1977 Corvette: Service Bulletin: Anti-Theft Alarm Switch - Protective Grease

Bulletin No: 77-T-57

Date: Oct., 1977

FIGURE #1 - DOOR LOCK/ANTI-THEFT SWITCH INSTALLATION

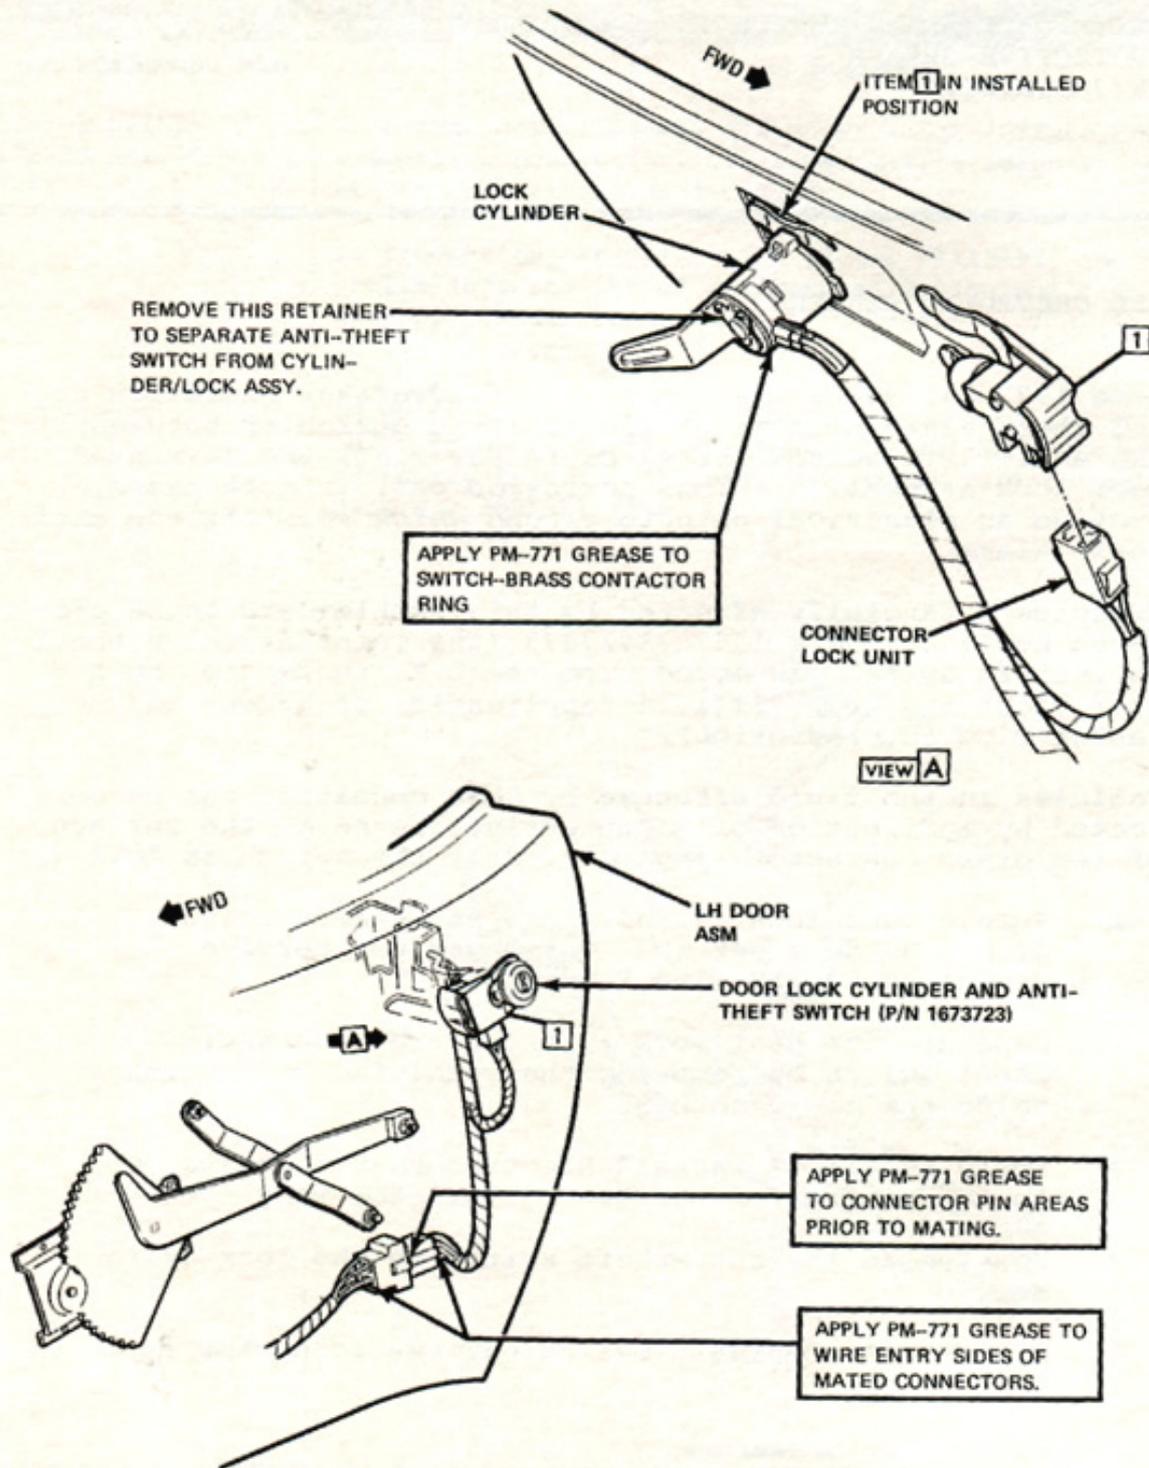
Some 1977 Corvettes may experience inadvertent operation of the theft alarm because of electrolytic corrosion between the anti-theft switch (brass contactor ring) and left hand door lock assemblies. This corrosion can, in some cases, provide an electrical path to ground which sets off the anti-theft alarm.

Vehicles potentially affected by this problem are those produced between VIN's 1Z37L7S427373 (the point at which the anti-theft switch was moved from the L.F. fender to the L.H. door lock) and 1Z37L7S441024 (application of grease to contactor ring in production).

Vehicles in the field affected by this condition can be corrected by application of a protective grease to the surface of the brass contactor ring portion of the switch as follows:

1. Remove door lock cylinder and anti-theft switch from L.H. door per 1977 Passenger Car Service Manual pg. 2D-19 (See Figure 1).
2. Separate the door lock cylinder from the anti-theft switch by removing the retaining ring which holds the two together.
3. Apply a film of Packard Electric PM-771 grease to the surface of the

brass contactor ring.

4. Reassemble the anti-theft switch to the lock cylinder.
5. Disconnect the theft switch harness connector from the door wiring harness connector and apply the same grease to connector pin areas. Reassemble connectors and apply this grease to the wire entry sides of the mated connectors.
6. Reassemble the door lock cylinder and anti-theft switch to the L.H. door per Service Manual instructions.

A satisfactory substitute for Packard Electric PM-771 grease is GM P/N 1050109 or 1050110.
